CONSTRUCTION PLANS
FOR
SKYLINE AT LORSON RANCH FILING NO. 1
STORM SEWER
CONSTRUCTION PLANS
including STREETS (FOR INFORMATION ONLY)

PUDSP-21-002

SKYLINE AT LORSON RANCH FIL. NO. 1
STORM SEWER
CONSTRUCTION PLANS

SHEET NUMBER C7.2

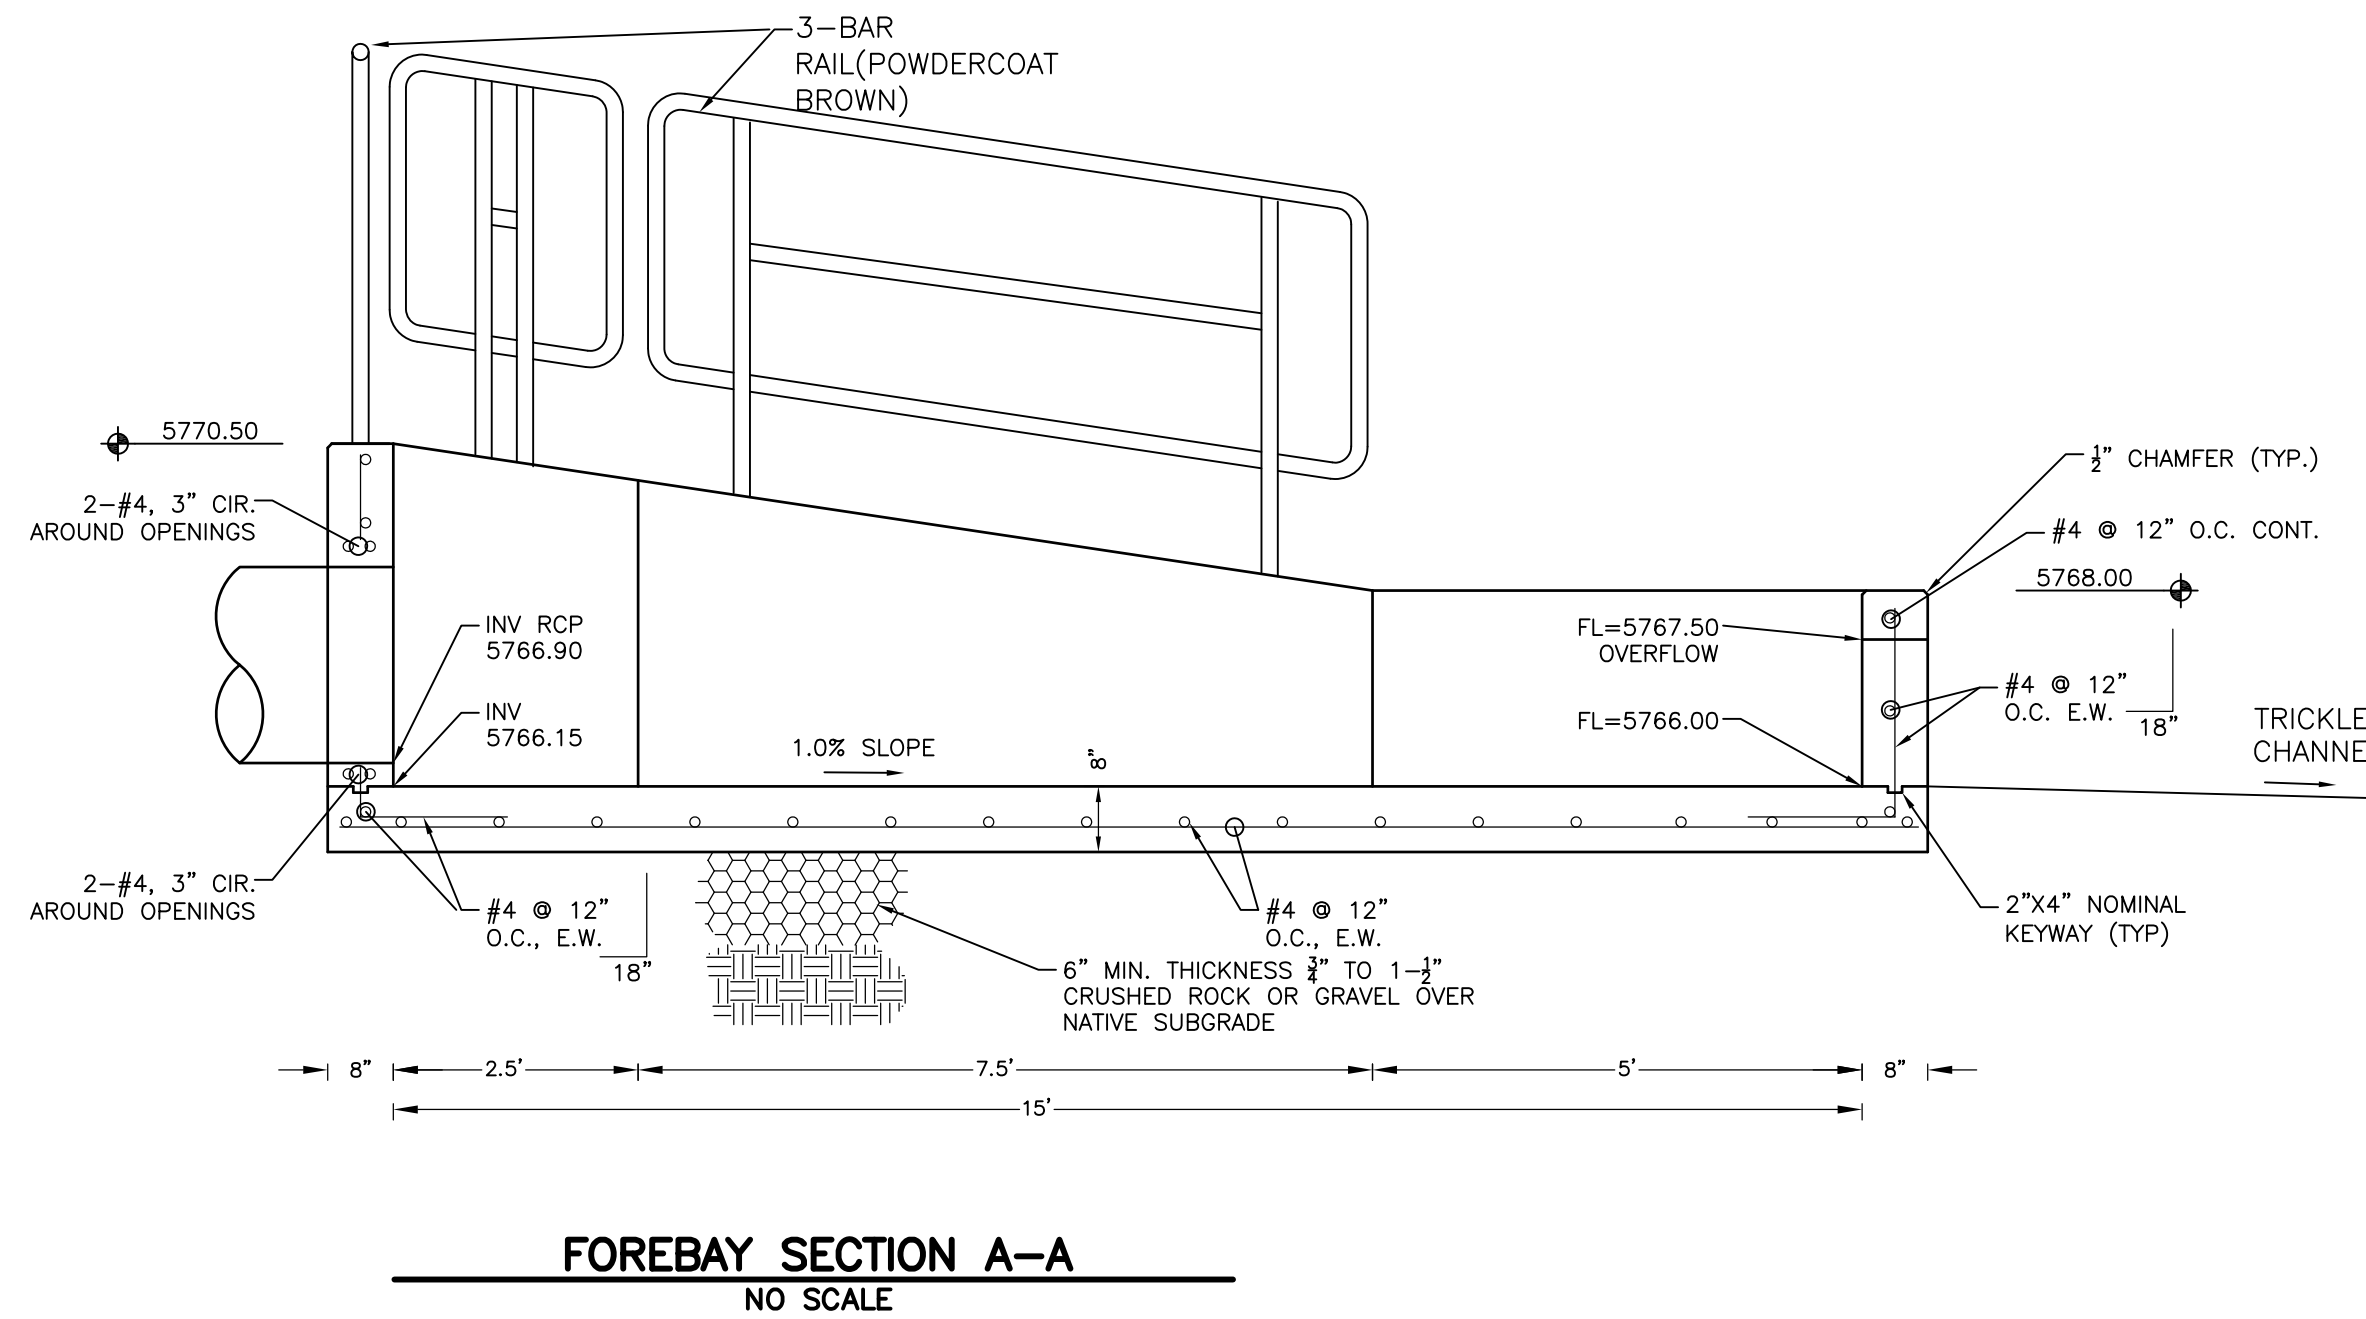
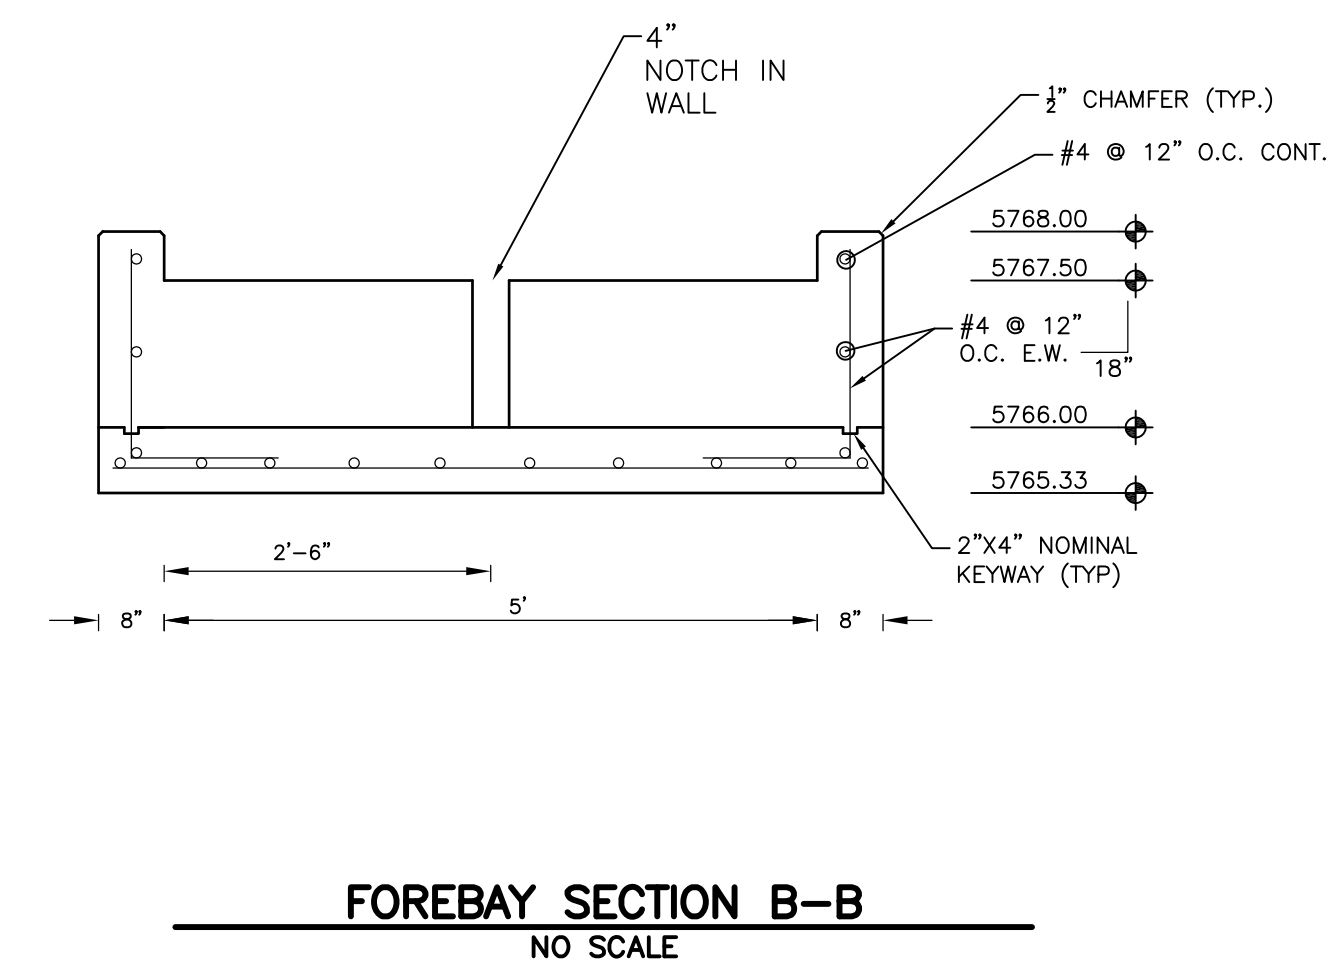
Verify that the inlets aren't too close to the ped ramps with depressions...
